09-AFC-5

Groundwater modeling analysis

Layne Christensen Company for Abengoa Solar

January 15, 2010

2042 difference results

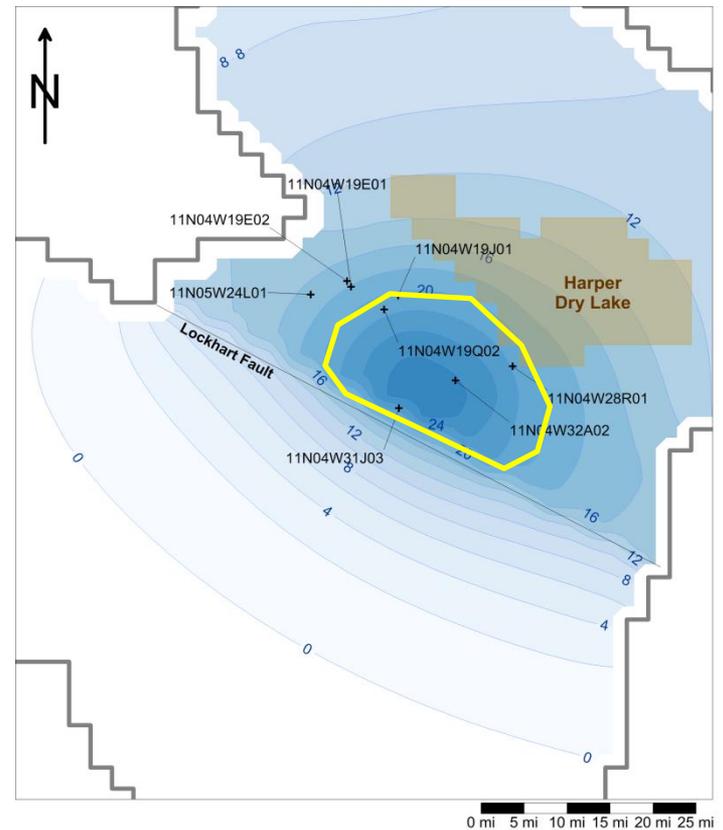
- Review of the updated USGS model identified two issues related to the conversion of the Stamos model
 - The steady-state 1931 model files included a 60 cfs recharge well (the text of USGS WRIR 01-4002 reported 10 cfs)
 - The first stress period length was improperly converted by Groundwater Vistas
- Neither of these issues were expected to significantly change the model results
- The change to the steady-state 1931 model only affects initial conditions for the transient predictive runs

Corrected 1931 initial condition

Pathline analysis for 1931 ambient conditions; 1000 years between dots

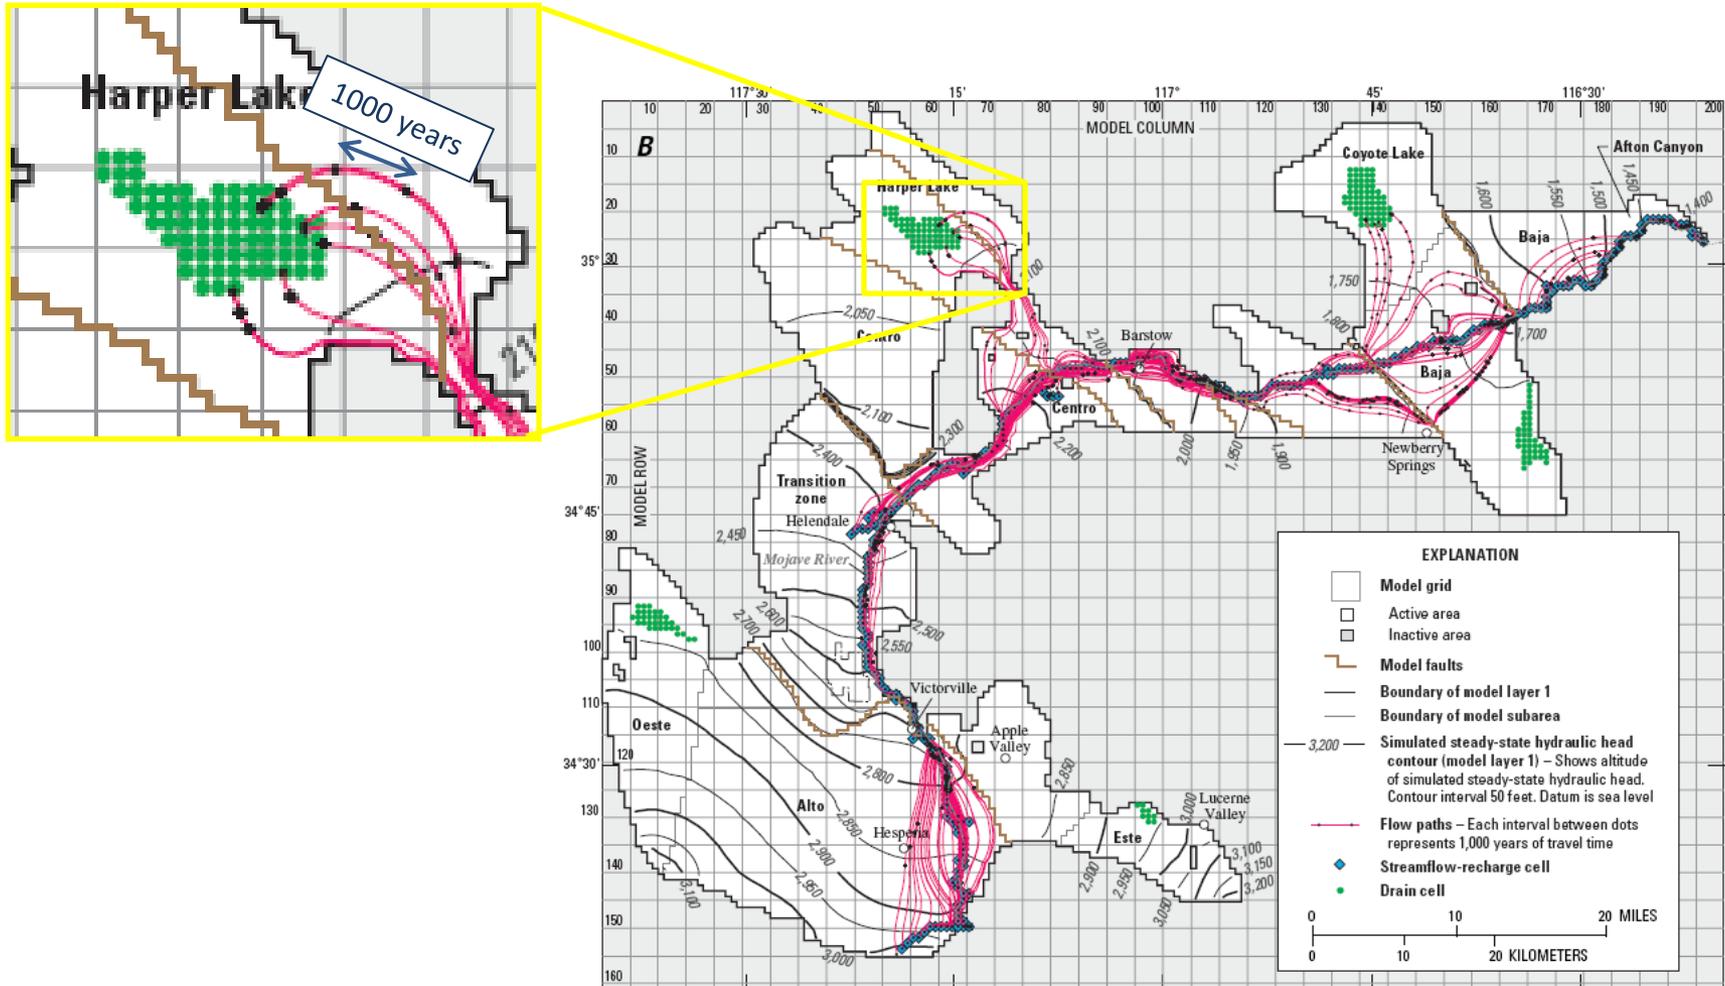
- CEC requested that the pathline plot for groundwater travel (Figure 22 A-2) trajectories from Harper Dry Lake be modified to identify travel times
 - Model has been modified
 - Internal errors from Groundwater Vistas have prevented completion of this task at this time
 - We will respond as soon as possible
 - We provide the Stamos travel time plot for comparison

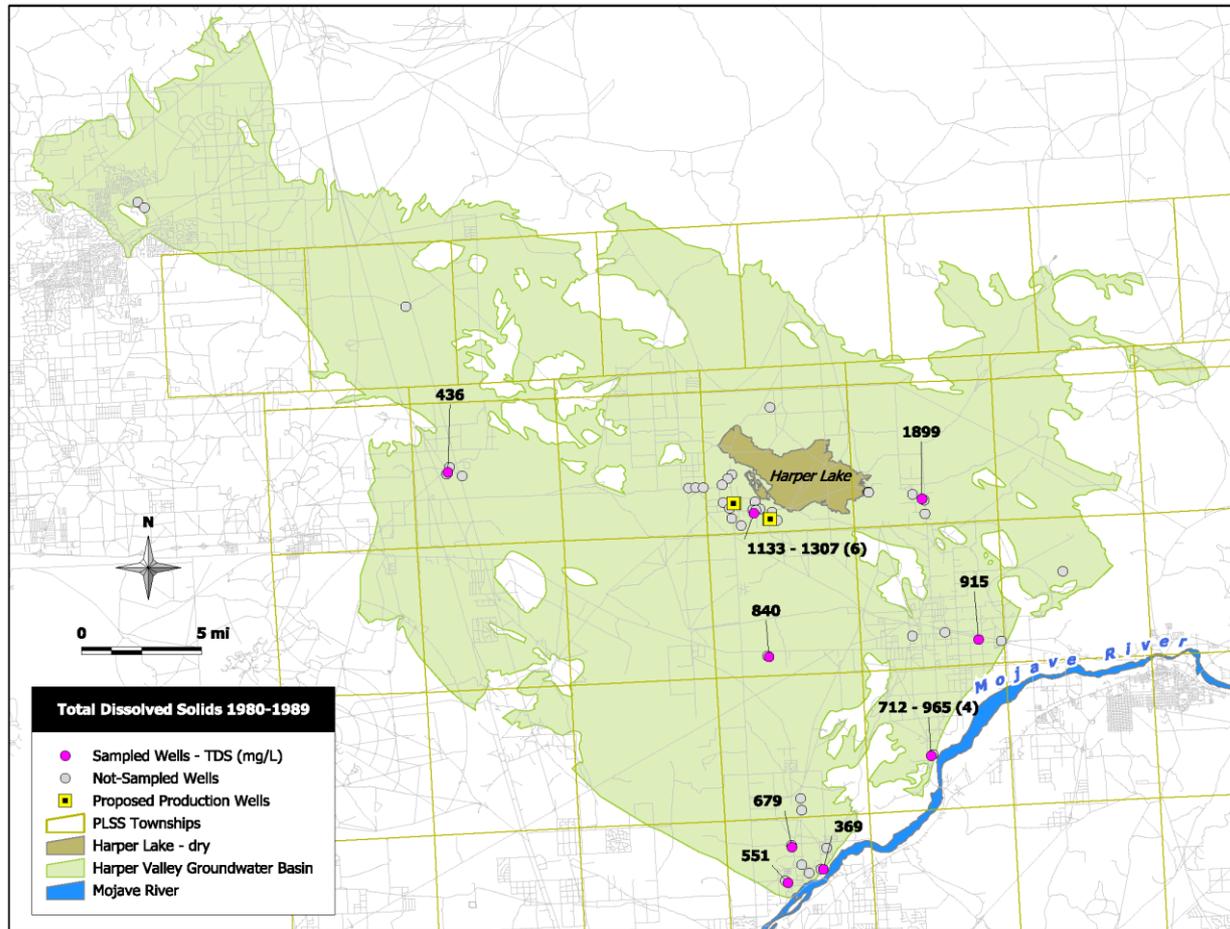
- CEC requested specific predictions of TDS in the Abengoa wells
- Major concern was whether TDS exceeds the 1500 mg/l threshold
- We examined the available data for three decades: 1980s, 1990s, 2000s
 - Summarized the range of measurements at specific wells over each decade
 - Superimposed the summary on a map of HVGB

In the 1980s, nearby measurements ranged from 1133-1307 mg/l
